Mack Chassis -Technical Service Bulletin M-284 - 068, Exhaust Particulate Sensor, Repair (2016 Vehicles)

Exhaust Particulate Sensor, Repair

V-284-068

(October 2020)

Repair 6

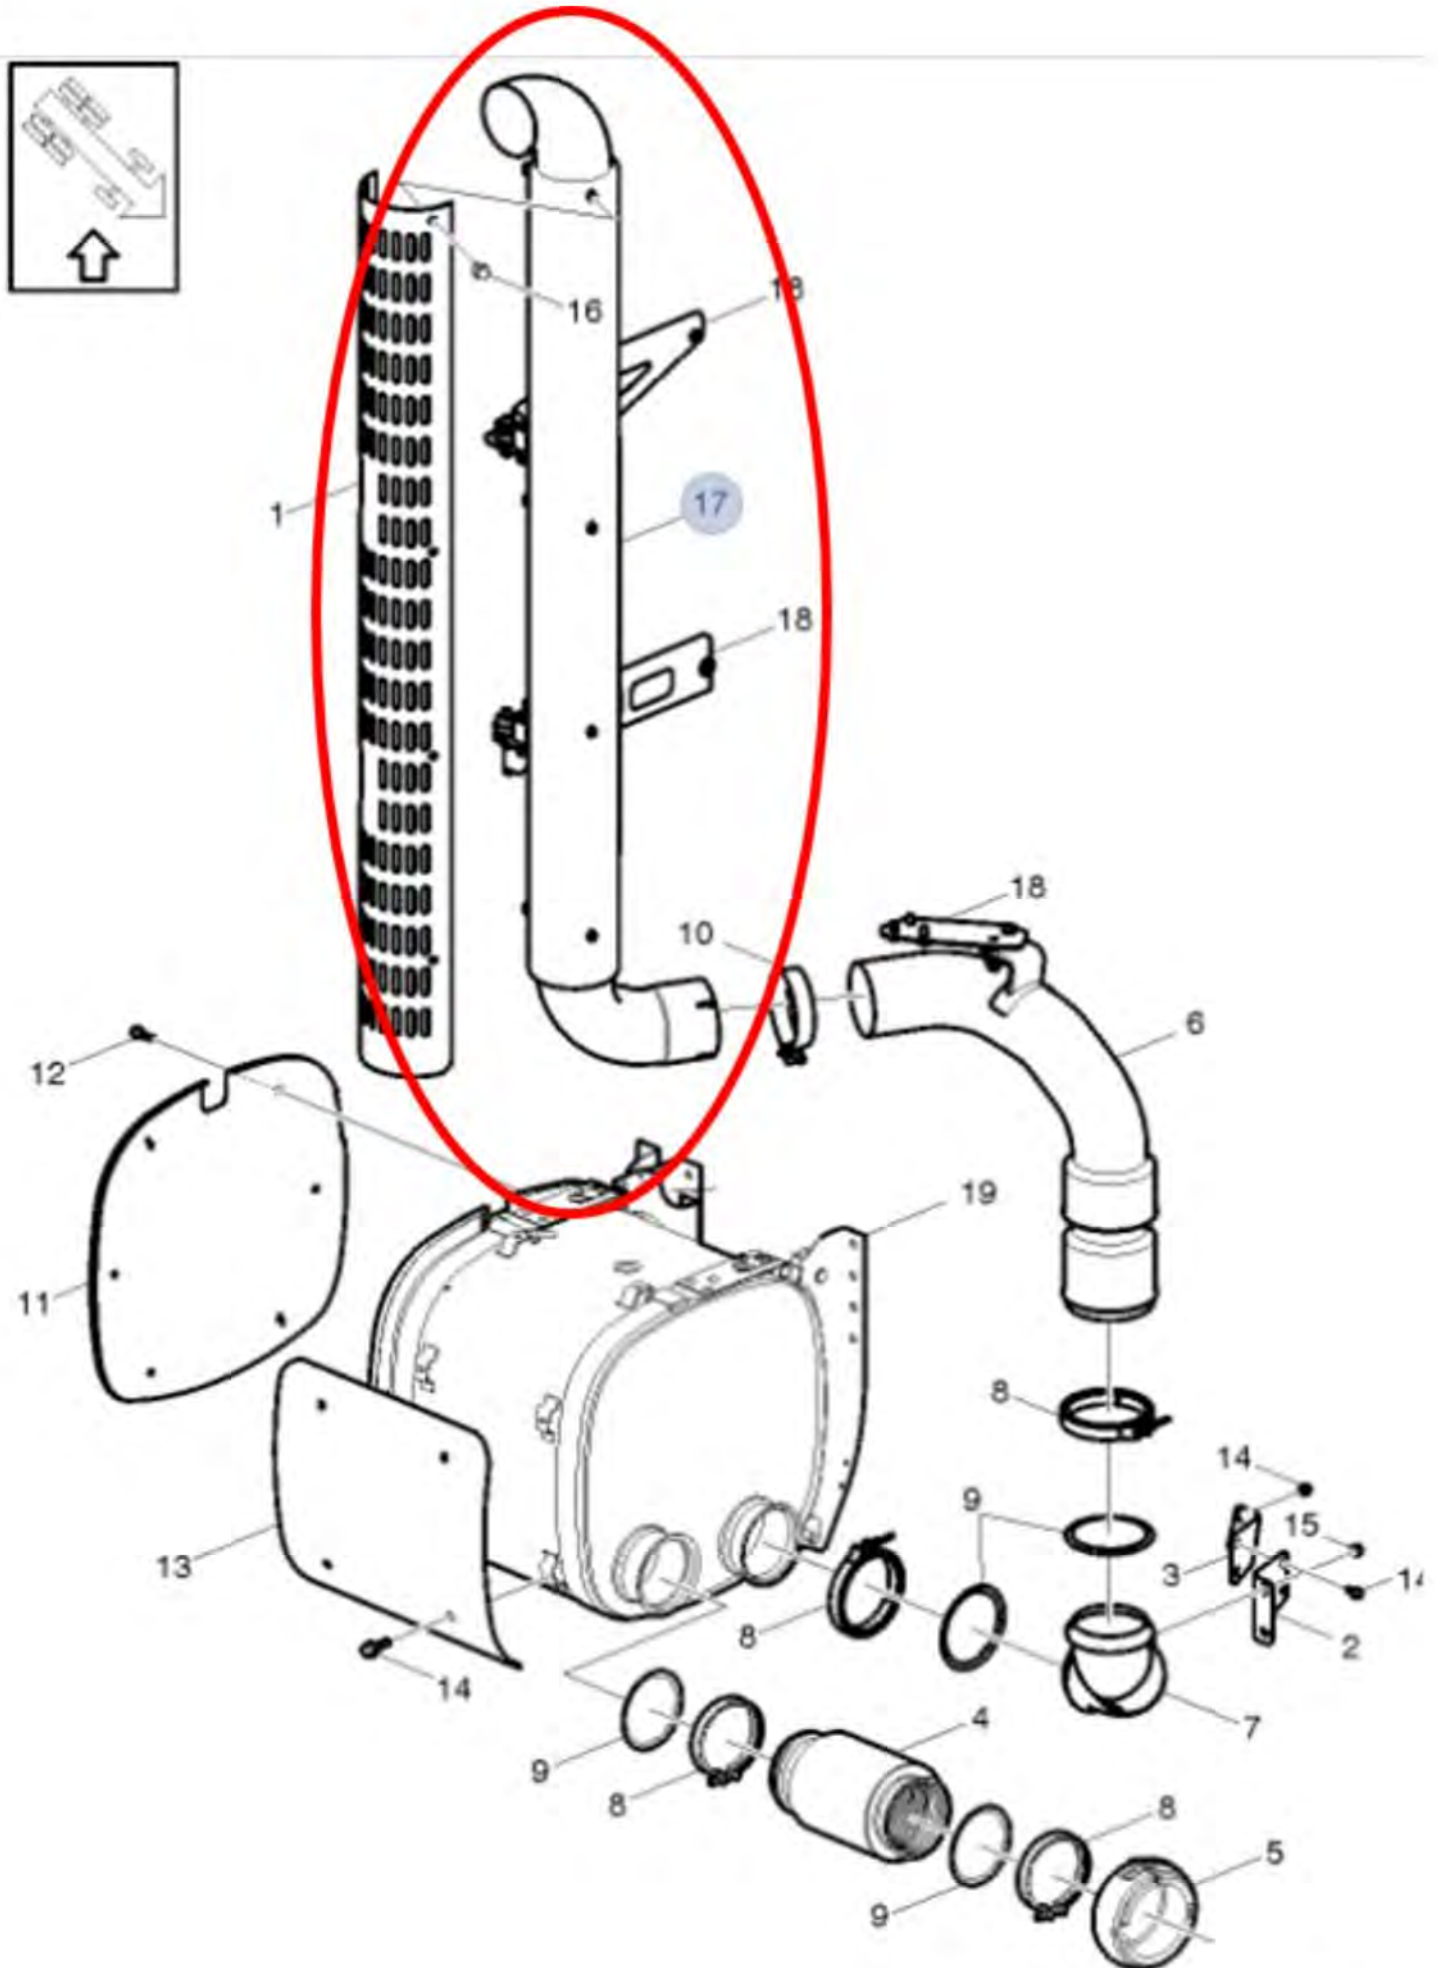
Model	Cab Type	Exhaust Configuration	Pipe 1	Clamp (Qty will vary)
VHD/VNM	Cab Mounted	SCR RH Horizontal Forward Mount	23154823	20961913
VHD/VNM	Cab Mounted	SCR Horizontal	23154825	20961913
VNL 11/13	Cab Mounted	SCR Horizontal	23154827	20961913

Repair 7

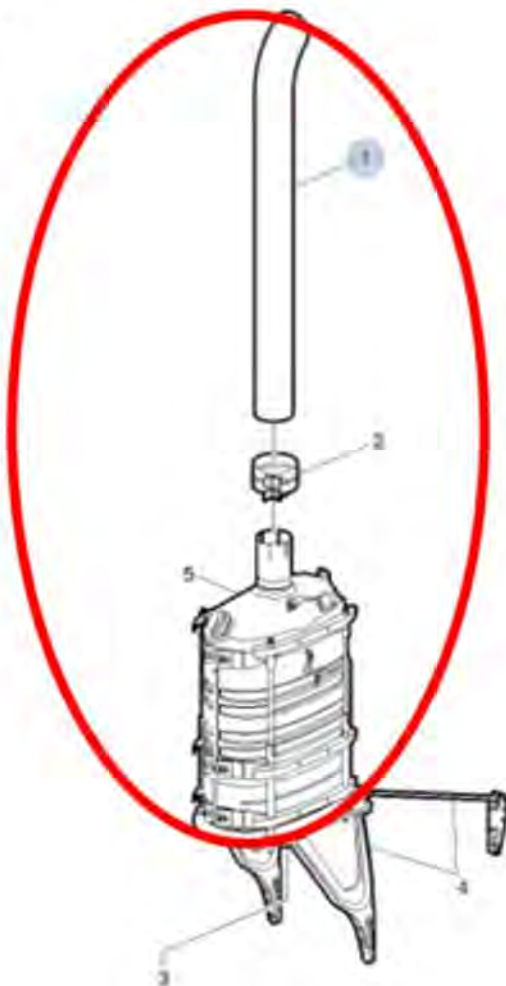
Model	Cab Type	Exhaust Configuration	Pipe 1	Pipe Insert	Clamp (Qty will vary)
-------	----------	-----------------------	--------	-------------	-----------------------

vary)
All	16L	12.5 ft Exhaust Stack Right Side	23208705	23296273	23189982
All	11L / 13L	11 ft 8 in Exhaust Stack Right Side	(Not Bright) 23208698 (Bright) 23208699	23176623	23189982
All	11L / 13L	12 ft 6 in Exhaust Stack Right Side	(Not Bright) 23208700 (Bright) 23208701	23176623	23189982
All	11L / 13L	13 ft 5 in Exhaust Stack Right Side	(Not Bright) 23208702 (Bright) 23208703	23176623	23189982
